**Broadway Corridor Task Force**  
**ReCode Comments & Requests for Submission**  
Draft 2 Text, Draft 1 Map  
20 September 2018

**DK Zoning North of I-40, C-N Zoning Between Lamar & Moran St – 4<sup>th</sup> & Gill Periphery**

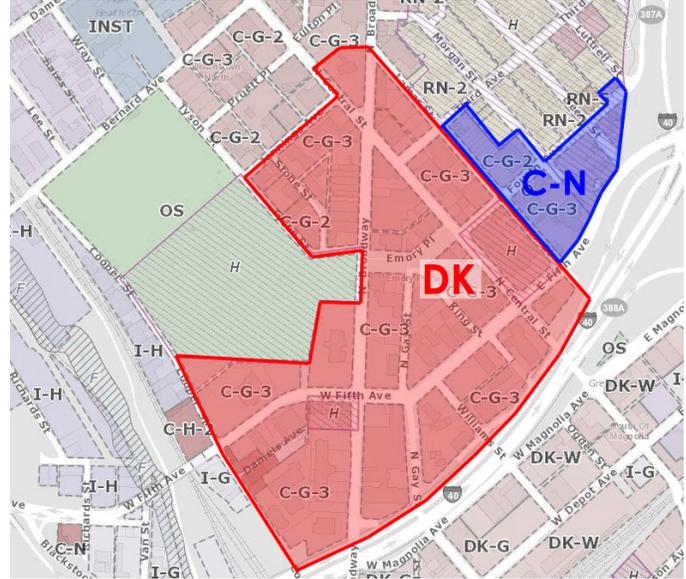
We recommend DK zoning north of I-40 to the intersection of Central and N Broadway, allowing downtown expansion North of I-40, and reducing the number/allowance of surface parking lots. We believe this expansion of downtown has already taken place, and that DK zoning is more appropriate than the currently proposed C-G-3. We believe DK-H, DK-B, or a hybrid of the two is appropriate.

Additionally, we request parcels between Lamar Street, Morgan Street, and 5<sup>th</sup> Avenue (currently proposed C-G) be zoned C-N to keep various existing historic single family or multi-family residences in-tact, and serve as a buffer between the DK zone and 4<sup>th</sup> & Gill neighborhood.

**C-G-2 Zoning; Broadway between Central and Hall of Fame**

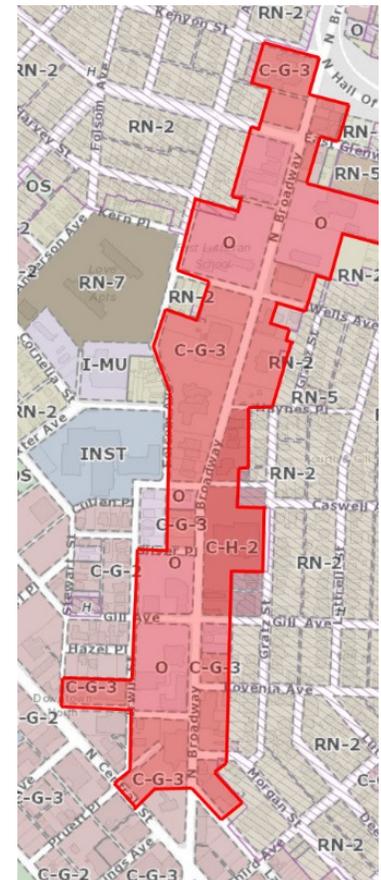
Though we support and recommend DK zoning north of I-40 to the intersection of Central and N Broadway, we see this intersection as a transition point with regards to height and density. Currently all of these properties are proposed as C-G-3, however we believe the unlimited height restraint (even if reduced to 85') is too tall for this transitional section of corridor, which begins to be bound by residential parcels moving north from the intersection of Central and N Broadway.

We therefore recommend all parcels currently proposed as C-G-3 for this section of Broadway be reclassified as C-G-2, for the reduced height restraint (70') as well as the smaller build-to zone. This also matches in scale and follows precedent to the currently proposed C-G-2 zoning along N Central.

**621; 622; 625; 628; 629 Luttrell**

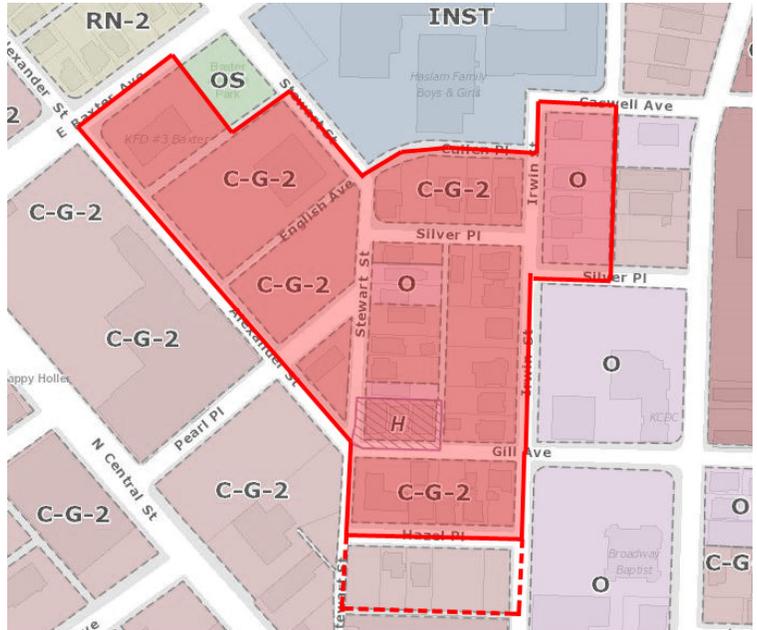
These properties on the corner of Luttrell and 3rd are currently proposed as C-G-2, yet are all historic single family residences. These properties should be zoned RN-2.

**915; 911 Gratz**

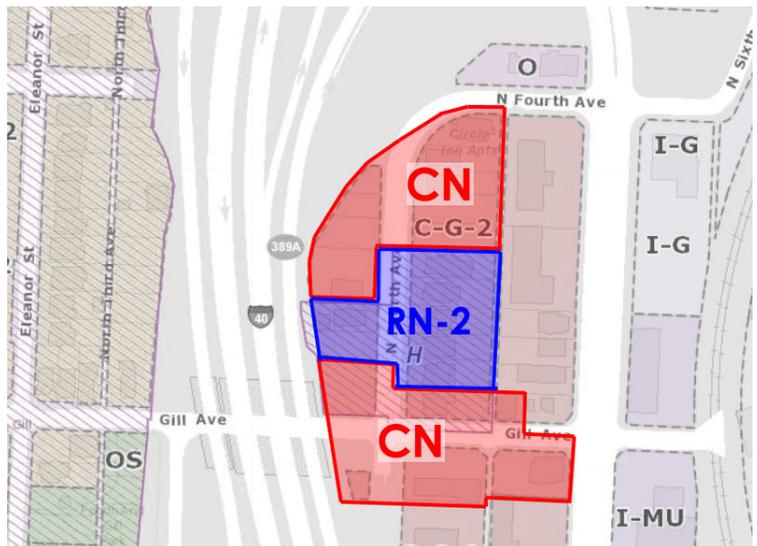
These residential properties on Gratz Street (abutting Broadway parcels) are historic and should not be rezoned to C-H-2. These parcels are also under a Historic Overlay, therefore we recommend these parcels to be zoned RN-2.

**Broadway, Between Gill Ave and Haynes Place**

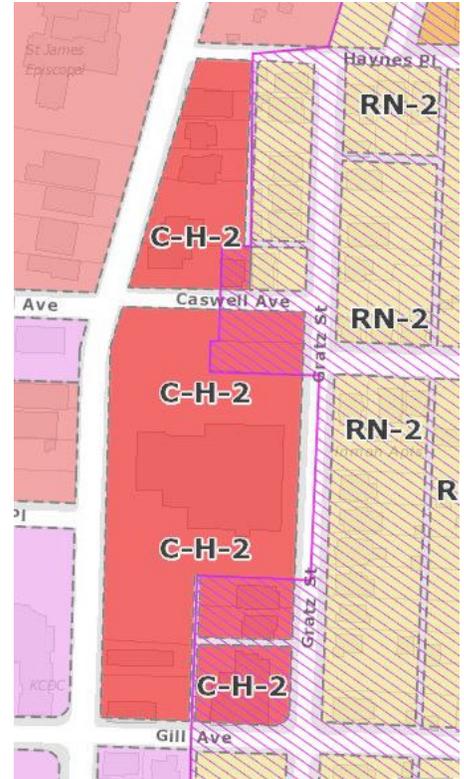
To remain consistent with neighboring properties (and our recommendations for zoning in this area) we recommend zoning these parcels C-G-2.

The extent of C-H-2 zoning in this area is inconsistent with the sector and one-year plan, which describes this area as a Multi-Use Urban Corridor. C-H-2 is of an auto-oriented character and doesn't make sense in the middle of an urban multi-use sector of a pedestrian nature, with single-family residences within walking distance. It appears C-H-2 was based upon the large parcel that is currently Broadway Carpets (930 N Broadway), however this parcel was developed after the 1960s and has setbacks and a lot size that is not in character/scale with the surrounding neighborhood.

The rest of these properties have a non-compliant minimum lot area (less than 10,000 sf) if zoned as C-H-2, which would not work with or support a minimum 20' setback. This largely applies to the properties between Caswell and Haynes.

**Kincaid Street R-N Zoning (as opposed to O or C-G)**

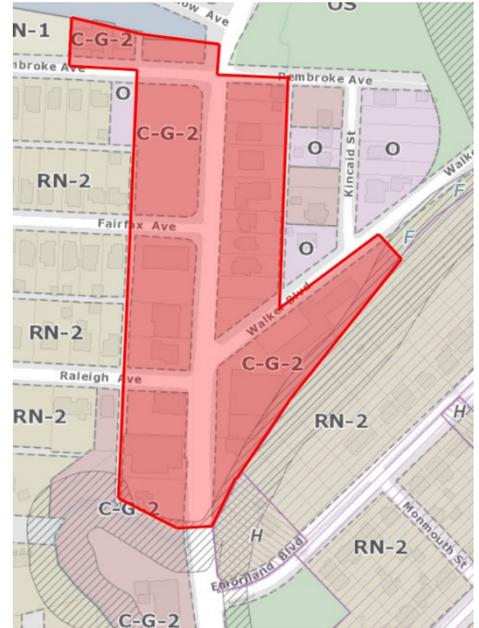
The recommended zone does not permit the current use - which is single family residential, and this neighborhood has been residential since the area was developed in the early 1900s. In fact, more of this area was residential until the 1960s and the current code. Our recommendation is that this area is rezoned RN-2 or C-N in order to avoid noncompliance and allow continued revitalization of these single family homes.
